WA STATE ENERGY CODE FORMS

CITY OF MERCER ISLAND

SCOPE OF CHANGE DOES NOT CHANGE SQUARE FOOTAGE OF CONDITIONED SPACE, INCREASES GARAGE AND DECK SQUARE FOOTAGE, NO CHANGE TO MECHANICAL OR

PROJECT TITLE:
Clarkson Residence
8163 West Mercer Way
Mercer Island, WA 98040

PROPOSED LOWER LEVEL FLOOR PLAN
1/4" = 1'-0"

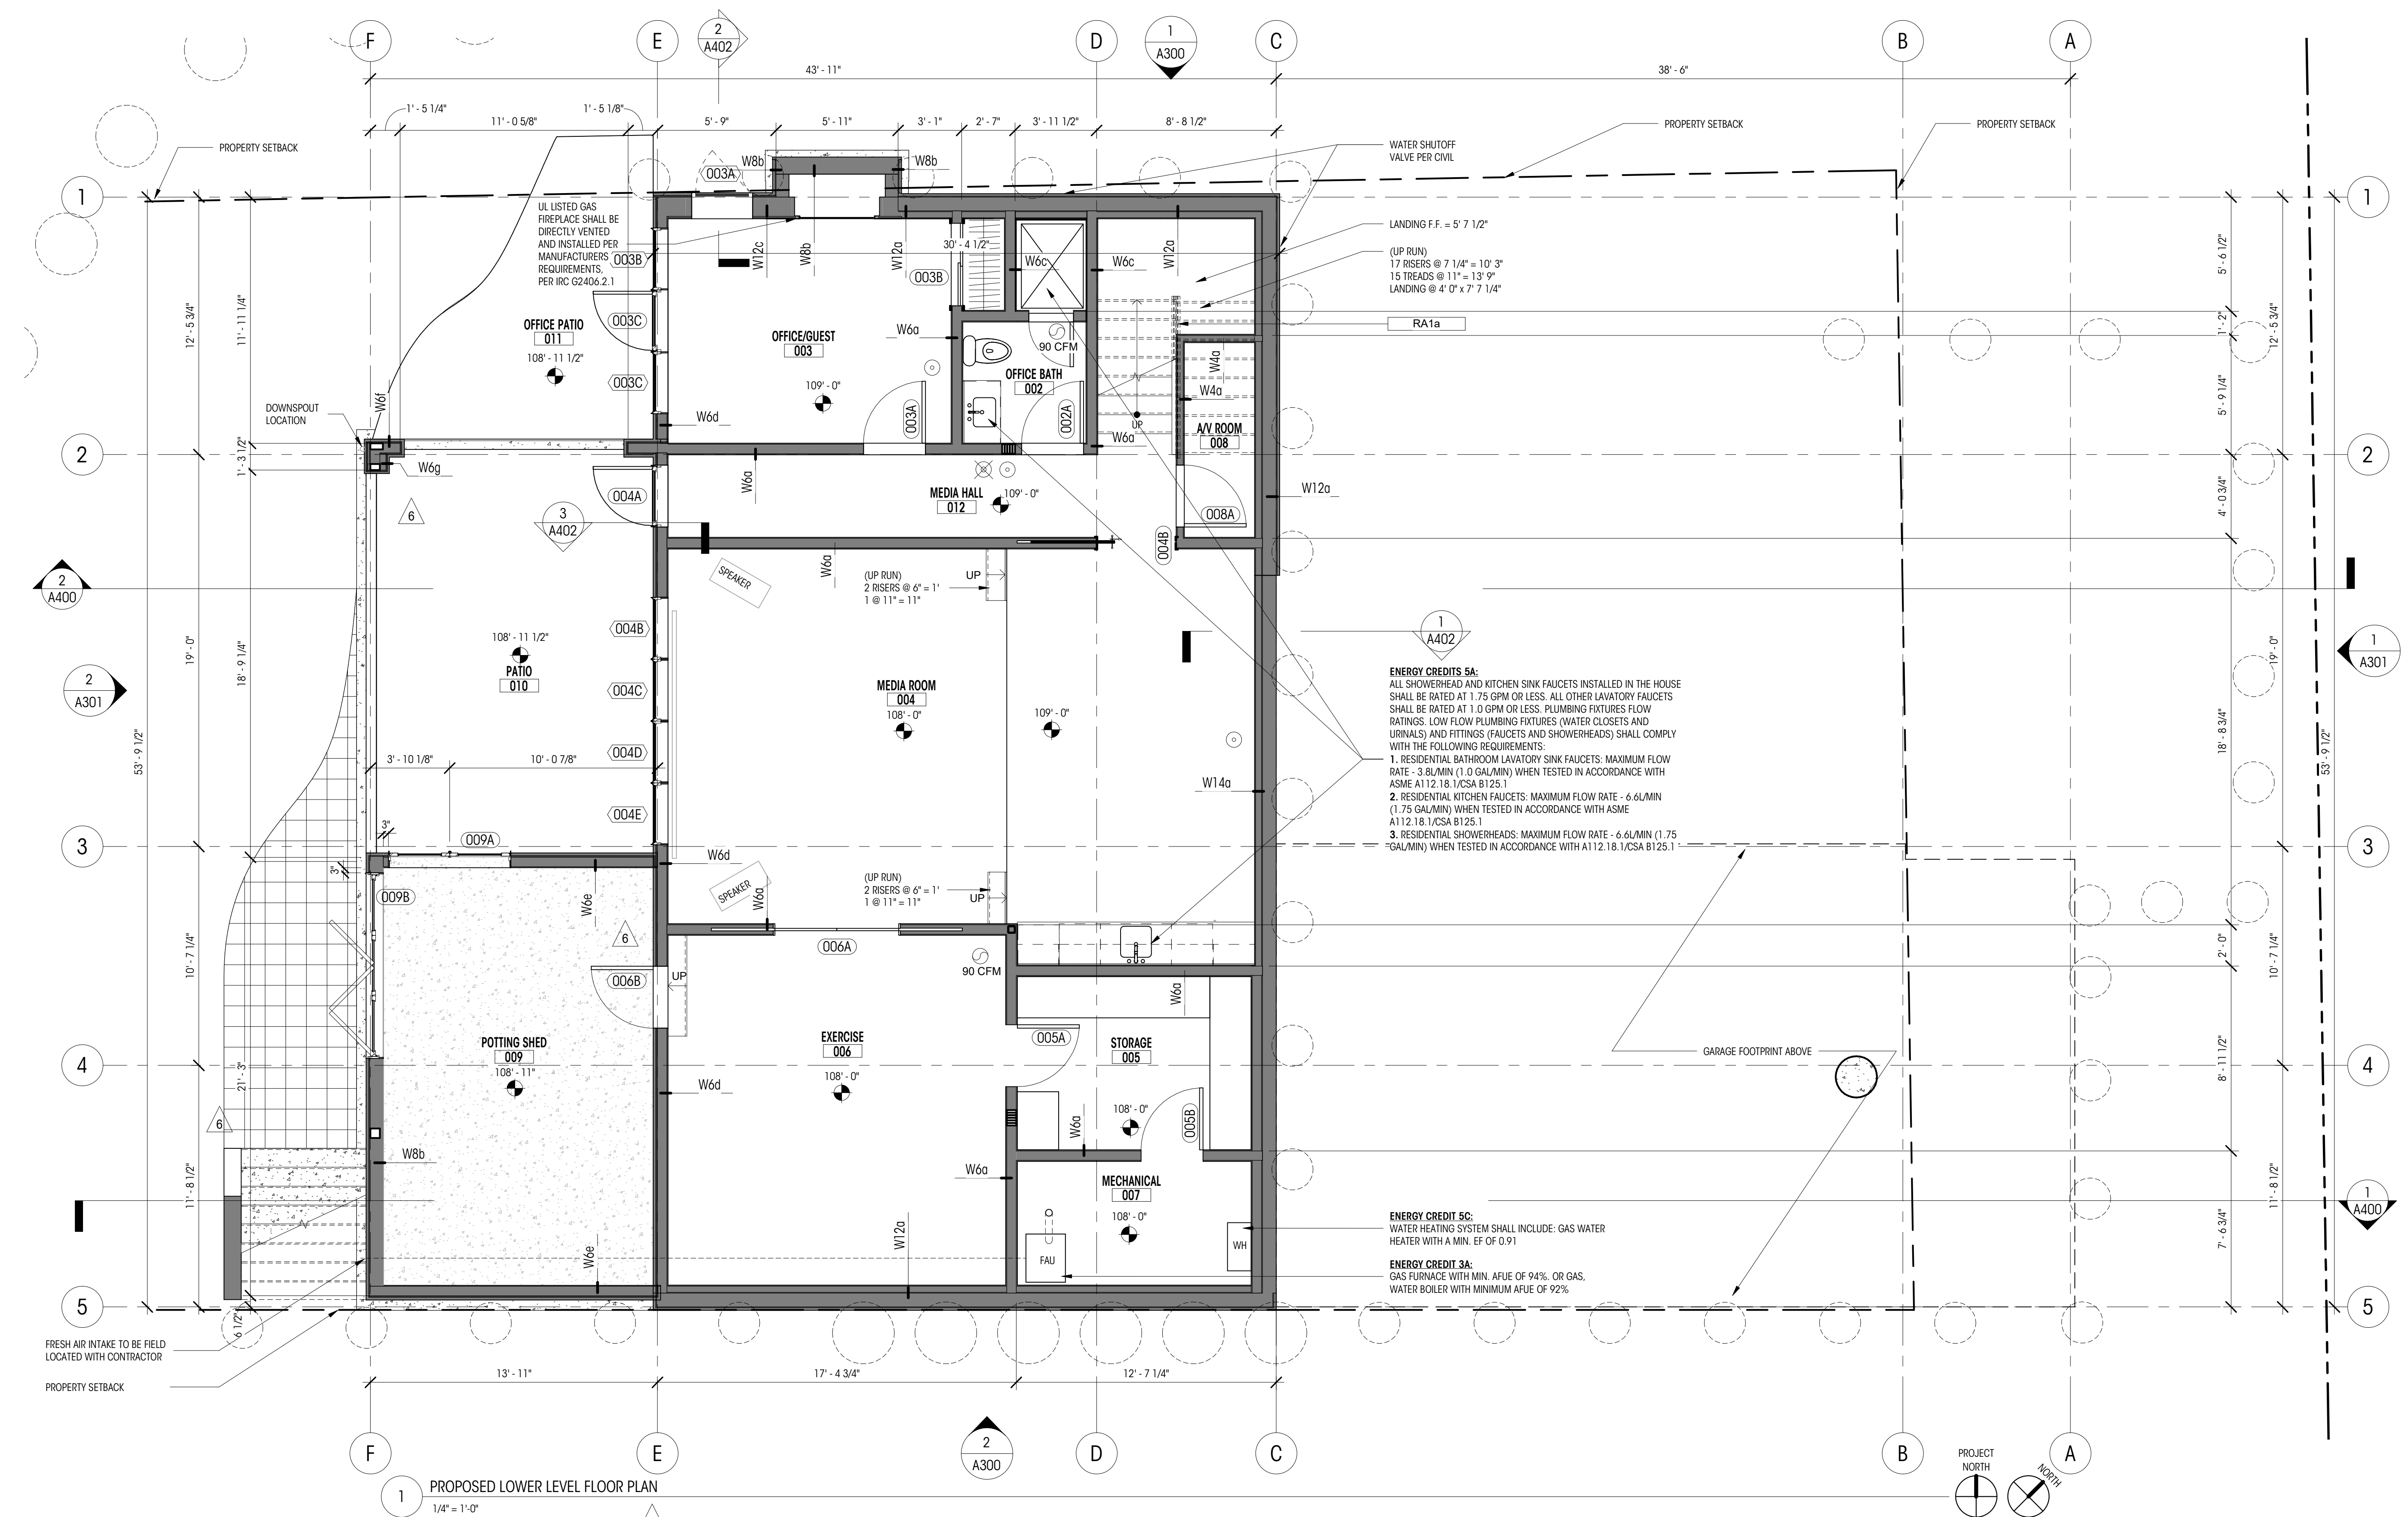
UPDATE TO LOWER LEVEL BASEMENT GFA REDUCTION PER PERMIT COMMENT.

1 PROPOSED UPPER LEVEL FLOOR PLAN
1/4" = 1'-0"

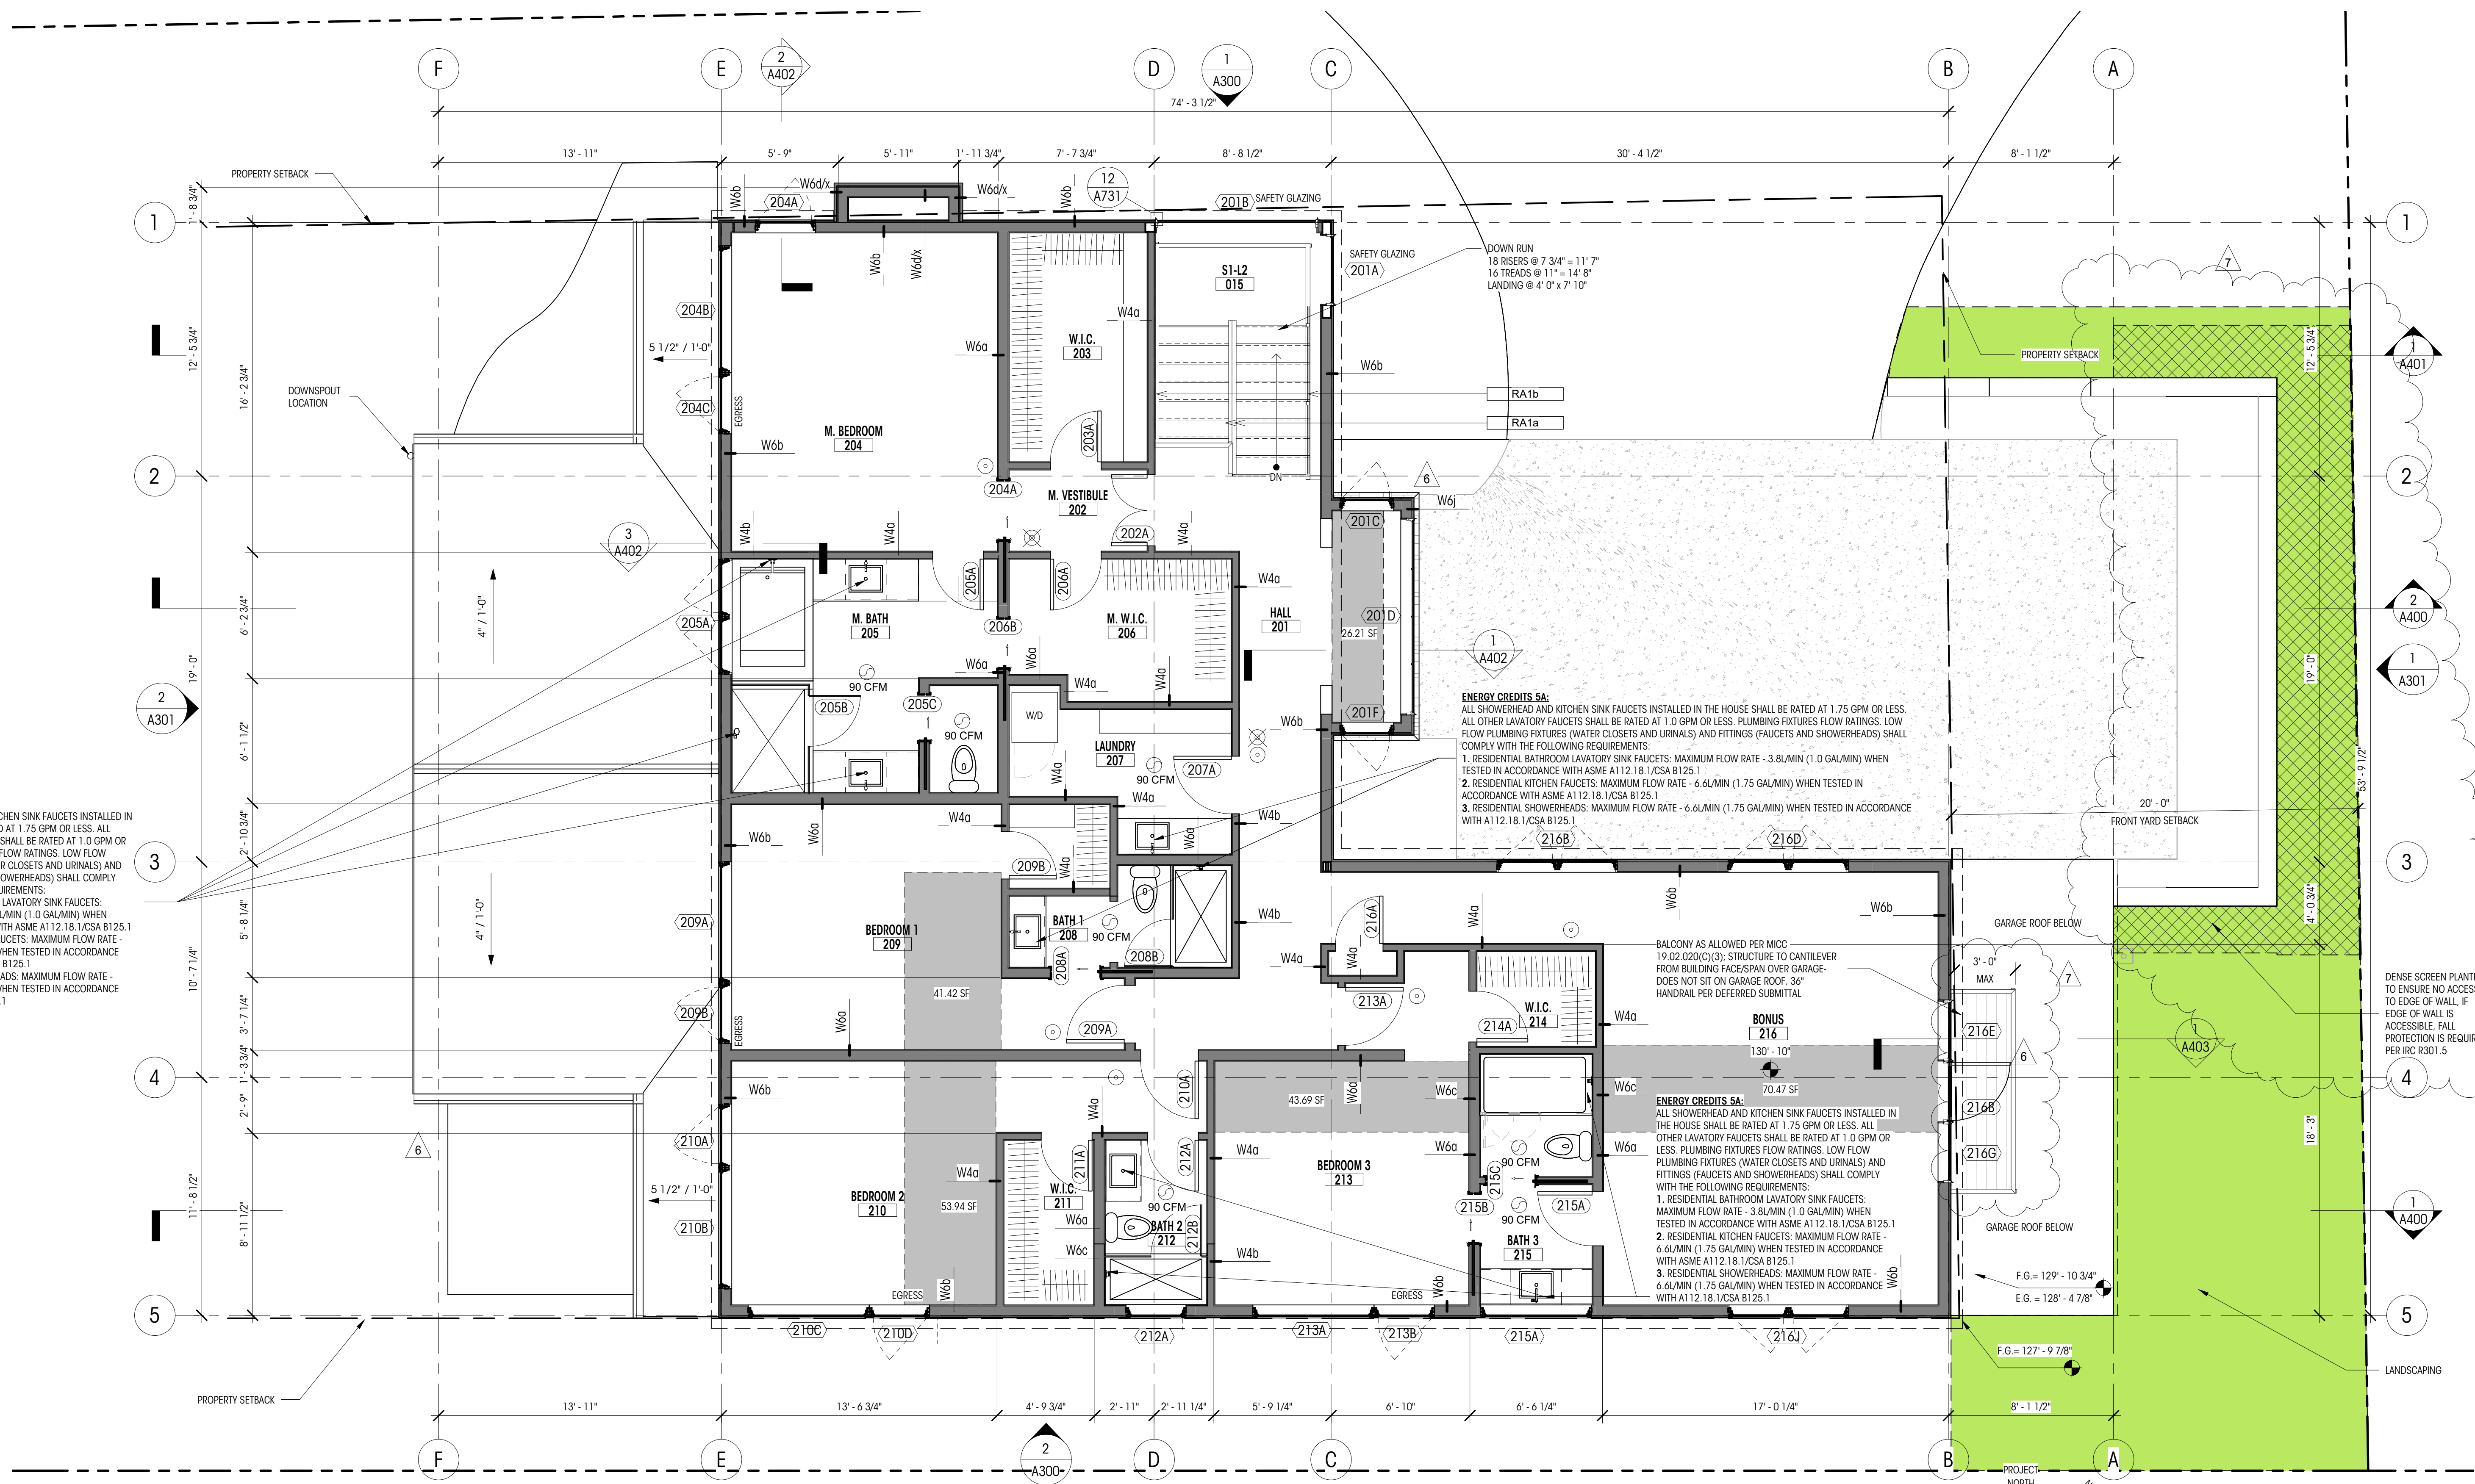
- JULIET BALCONY ADDED OFF OF BONUS ROOM
- DENSE SCREEN PLANTING GRAPHIC ADDED BACK IN
